TNO report 2014 R11646

**Evaluation of the proposal to allow VDSL2 from the
local exchange (EVDSL) in Ireland**

Technical evaluation of the CLFMP amendment proposal

Date 18 Nov 2014
Author Teun van der Veen

Fig 4 Topology 3: Lines in shared cable but not sharing same route:

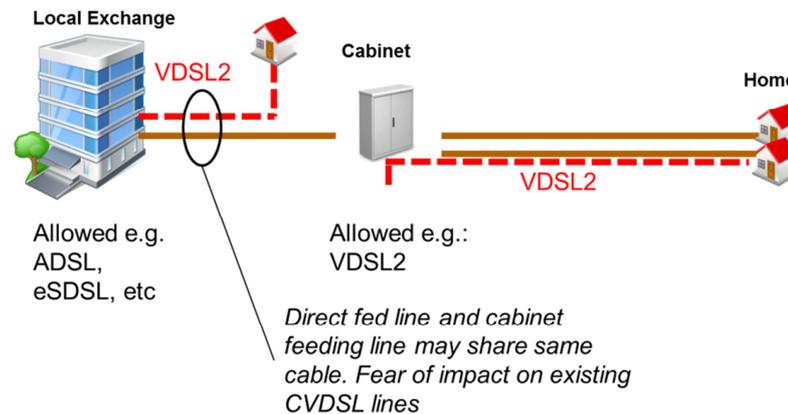
In none of the examined jurisdiction, the frequency management plans describe a situation that is similar to the Irish situation in topology 3 as depicted in fig 4.

The discussion is about the proposed CLFMP is topology 3. The main conclusion is: There is non-negligible risk of negative impact for specific cases.

The first option is to ALLOW EVDSL in topology 1 and to NOT allow EVDSL in topology 3 when cabinets are "too close" to the LEX. This option is based on the facts that:

The second option is to ALLOW EVDSL in topology 1 and to conditionally ALLOW EVDSL in topology 3. These conditions should be aimed at minimising and mitigating the risk of negative impact. These conditions are not elaborated further in this analysis, but they could be along the following lines:

Fig 6 The crosstalk coupling path in topology 3, downstream direction

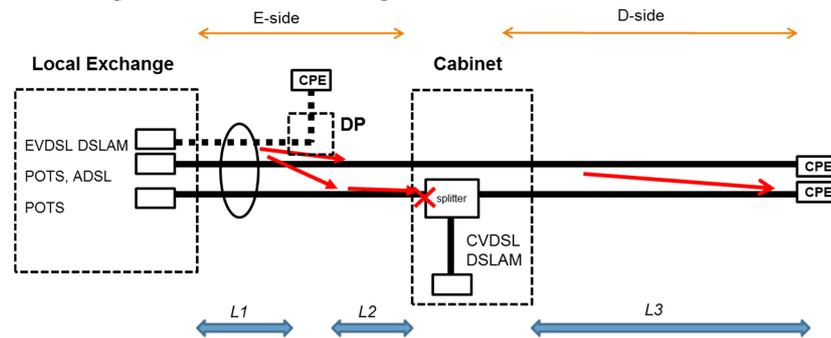
- Without detailed loop length statistics (L1, L2, L3 in figures 6 and 7) from the Eircom network, the test cases analysed cannot be judged on the level of representativeness.

Fig 11 Attainable rates downstream Pre and Post EVDSL activation (1 May 2014 and 22 June 2014 respectively), in cabinet SKS1_003

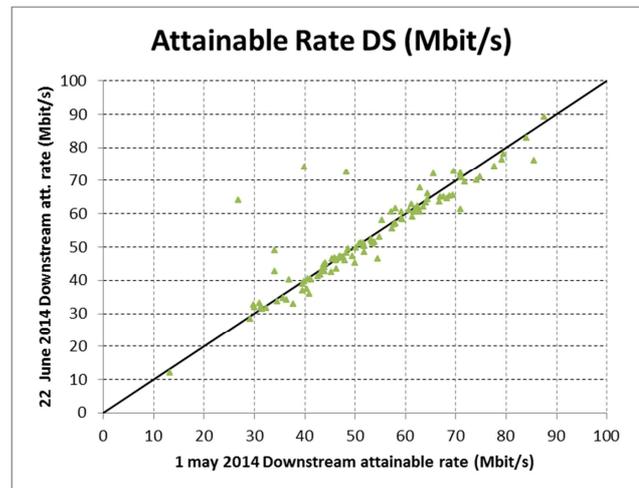
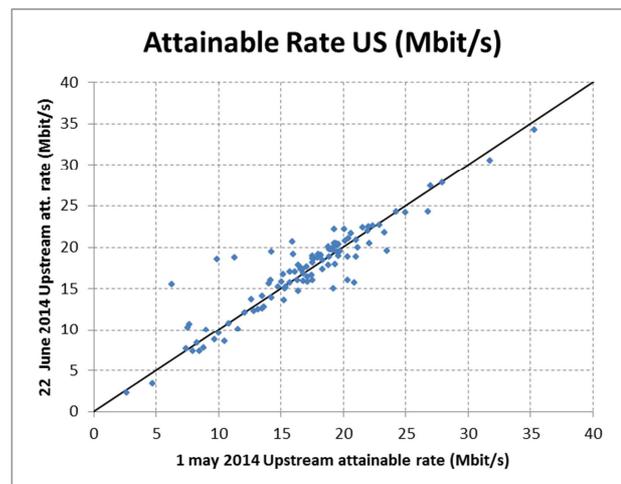
In the graphs above, two data sets of non-vectored CVDSL datarates are shown (both up- and downstream): The attainable bitrates of CVDSL on 22 June (with EVDSL active) are plotted against the baseline CVDSL attainable bitrates 1 May. The black line signifies “no performance difference” between the two datasets. From these plot, it can be seen that statistically speaking, the performance on these two dates is similar, both for downstream and upstream. This is an indication that EVDSL does not have a significant negative impact on CVDSL, with the remarks mentioned in chapter 3.

Fig 13 Attainable rates downstream Pre and Post EVDSL activation (1 May 2014 and 22 June 2014 respectively), in cabinet WST1_006

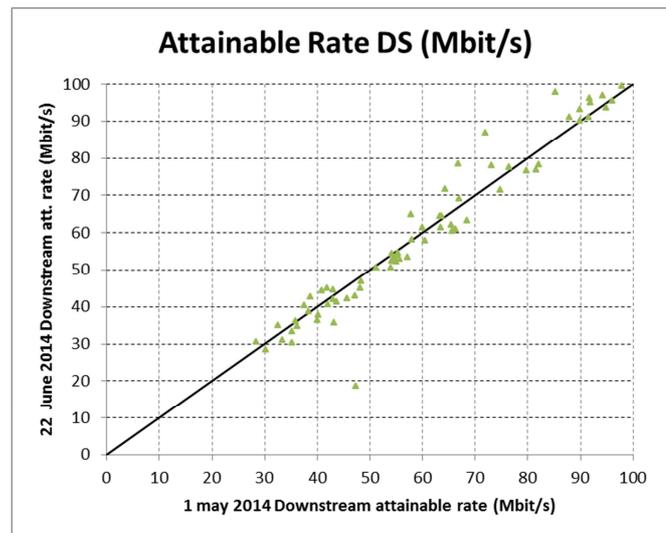
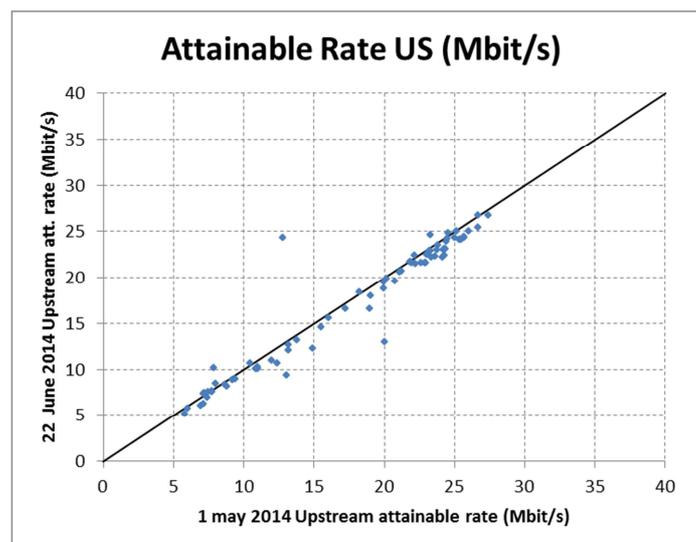
In the graphs above, two data sets of vectored CVDSL datarates are shown (both up- and downstream): The attainable bitrates of CVDSL on 22 June (with EVDSL active) are plotted against the baseline CVDSL attainable bitrates 1 May. The black line signifies “no performance difference” between the two datasets.

From these plot, it can be seen that statistically speaking, the performance on these two dates is similar, both for downstream and upstream. This is an indication that EVDSL does not have a significant negative impact on CVDSL, with the remarks mentioned in chapter 3.
